Access Compliance Report Public Rights-of-Way (Curb Ramps)

Intersection ID: 14033 Main Street: ELMIN_ST Cross Street: MORNING_DR Location: SW

ADA ID: 5A38BFC0648C Ramp Type: Combination1Diag Initial Pass/Fail: Fail Overall Compliance: No Severity Score: 0

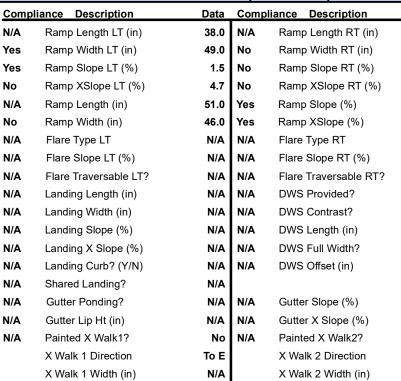
Surveyor Notes:

LT RP < 5%

PROW/ADA:

Not Found, R304.5.1, R304.5.1, R304.5.3, R304.3.2

Possible Solutions:

Remove & Replace Curb Ramp With Two New Directional Ramps or Equivalent.
